Proposed Revisions to a Standard Plans Index

Index Number: 102-201

Index Title: TEMPORARY ACROW SERIES 700XS DETOUR
BRIDGE BEAM AND GUARDRAIL DETAILS

THRIE BEAM TO BRIDGE GUARDRAIL TRANSITION

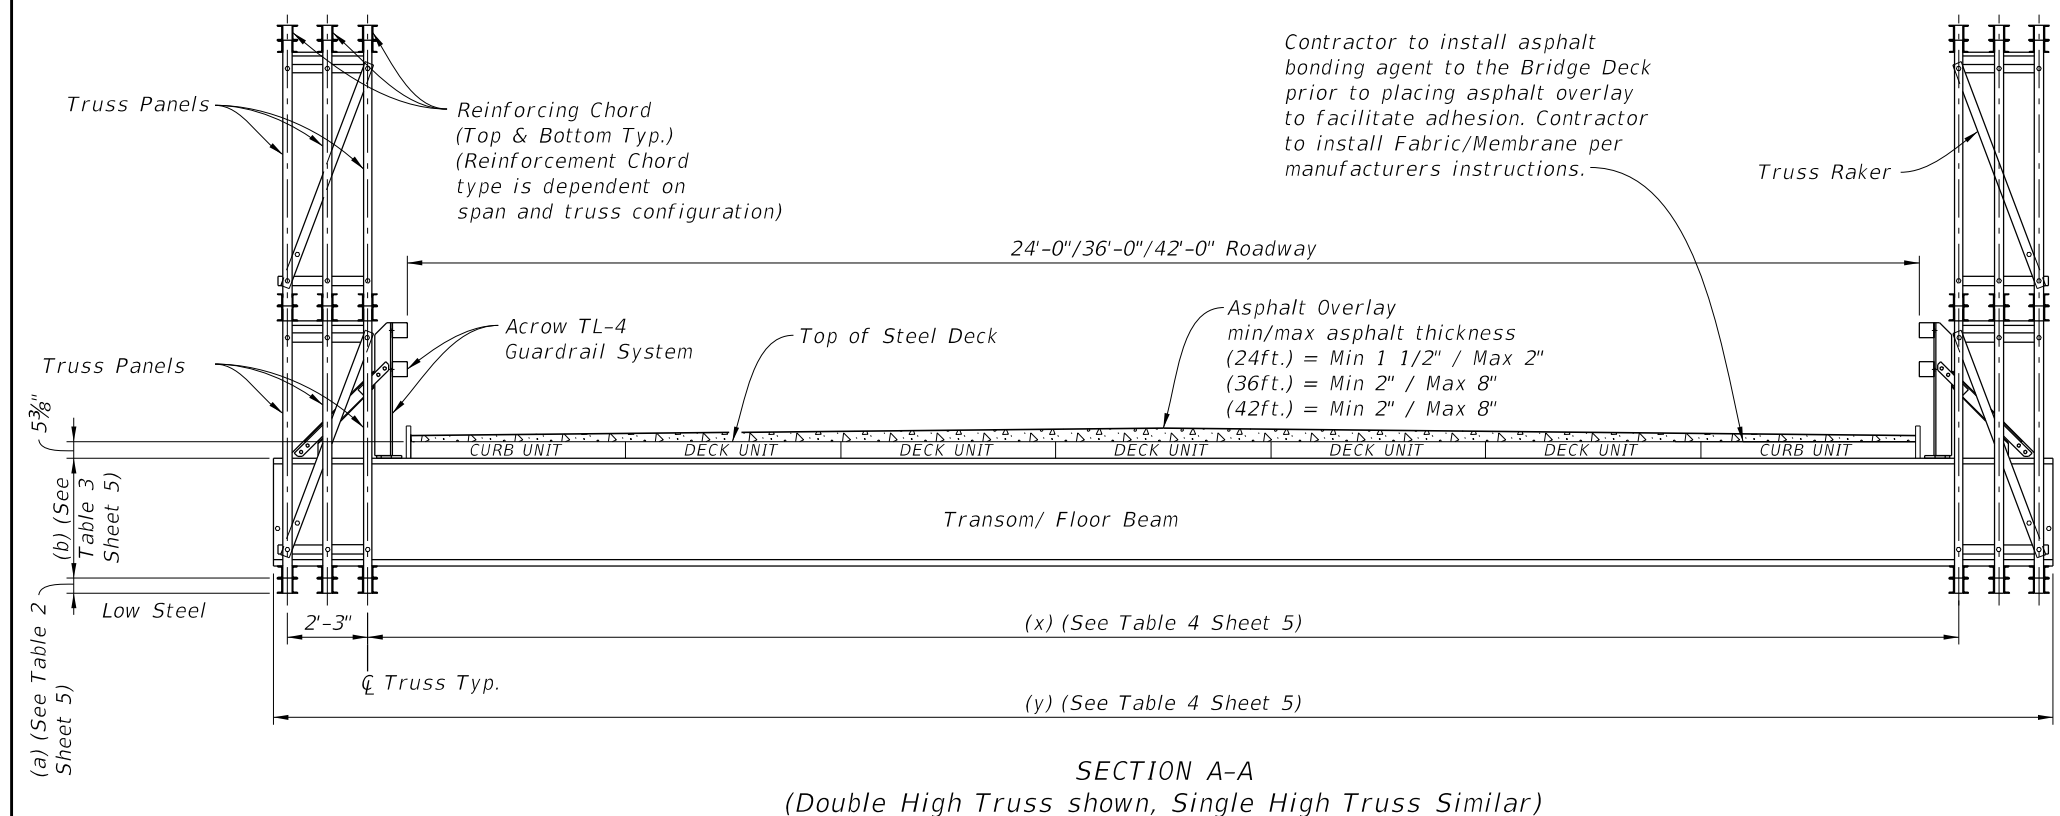
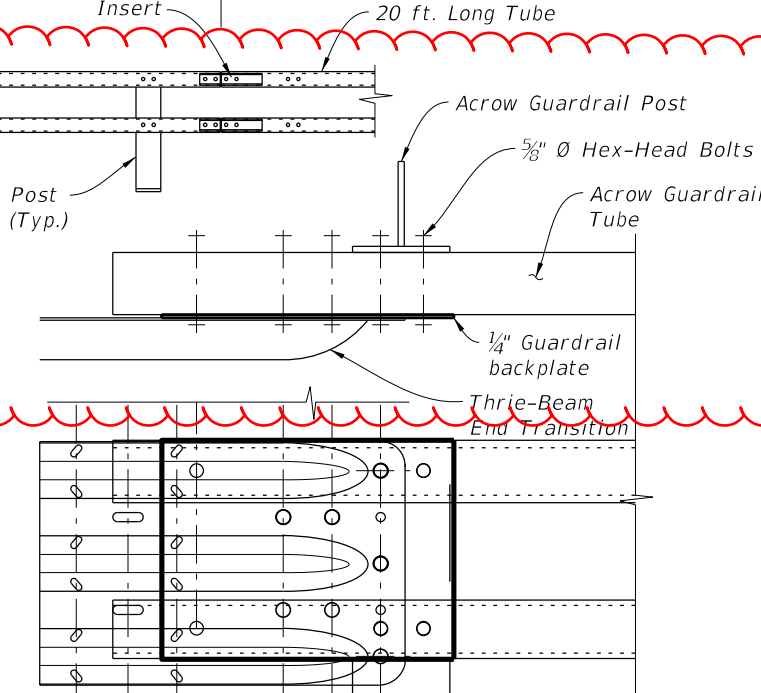
Updated drafting for clarity

1/4" GUARDRAIL BACK PLATE DETAIL

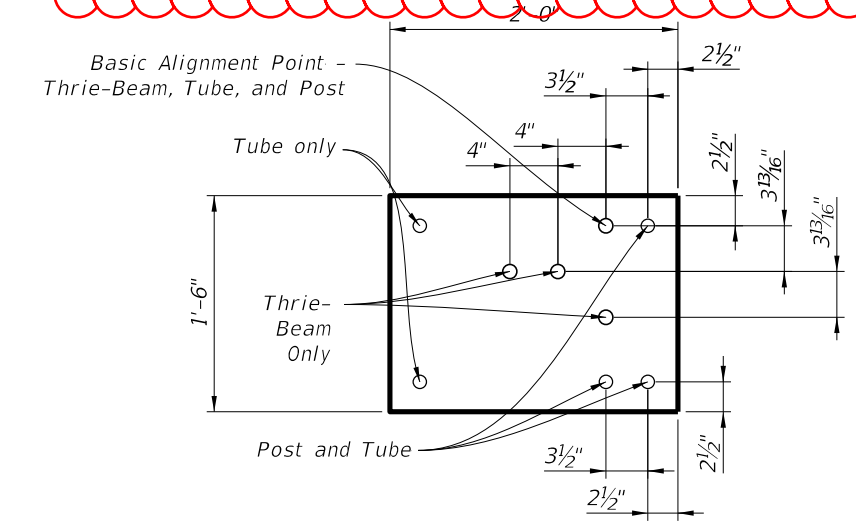
Sheet2: Updated guardrail backplate details to add clarifying information and remove errors.

Added detail for further clarity
